Access Compliance Report

Public Rights-of-Way

(Curb Ramps)

Intersection ID: 5813	Main Street: MALLARD_CREEK_RD	Cross Street: MALLARD_SQUARE_LN	Location: W
ADA ID: BD584DC64C33	Ramp Type: PerpDiag	Initial Pass/Fail: Fail	Overall Compliance: No
Codes/Mitigation Info/Possible Solution		Field Measurements/Component Compliance	
Severity Score: 8.75

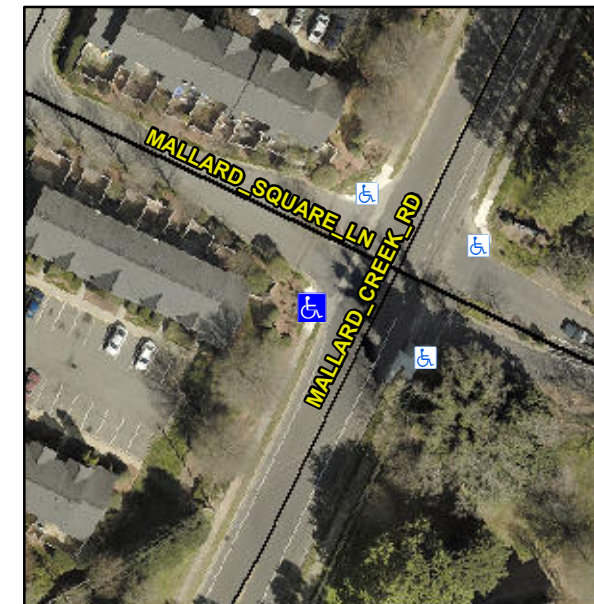
Not Found, R304.5.1

Compliance	Description	Data	Compliance	Description	Data
N/A	Ramp Length (in)	80.0	Yes	Ramp Slope (%)	7.4
No	Ramp Width (in)	47.5	Yes	Ramp XSlope (%)	1.6
N/A	Flare Type LT	N/A	N/A	Flare Type RT	N/A
N/A	Flare Slope LT (%)	N/A	N/A	Flare Slope RT (%)	N/A
N/A	Flare Traversable LT?	N/A	N/A	Flare Traversable RT?	N/A
N/A	Landing Length (in)	N/A	N/A	DWS Provided?	N/A
N/A	Landing Width (in)	N/A	N/A	DWS Contrast?	N/A
N/A	Landing Slope (%)	N/A	N/A	DWS Length (in)	N/A
N/A	Landing X Slope (%)	N/A	N/A	DWS Full Width?	N/A
N/A	Landing Curb? (Y/N)	N/A	N/A	DWS Offset (in)	N/A
N/A	Shared Landing?	N/A			
N/A	Gutter Ponding?	N/A	N/A	Gutter Slope (%)	N/A
N/A	Gutter Lip Ht (in)	N/A	N/A	Gutter X Slope (%)	N/A
N/A	Painted X Walk1?	No	N/A	Painted X Walk2?	No
	X Walk 1 Direction	To NE		X Walk 2 Direction	To SE
N/A	X Walk 1 Width (in)	N/A	N/A	X Walk 2 Width (in)	N/A
	X Walk 1 Slope (%)	0.1		X Walk 2 Slope (%)	2.6
	X Walk 1 X Slope (%)	0.2		X Walk 2 X Slope (%)	0.9

Remove & Replace Curb Ramp With Two New Directional Ramps or Equivalent.
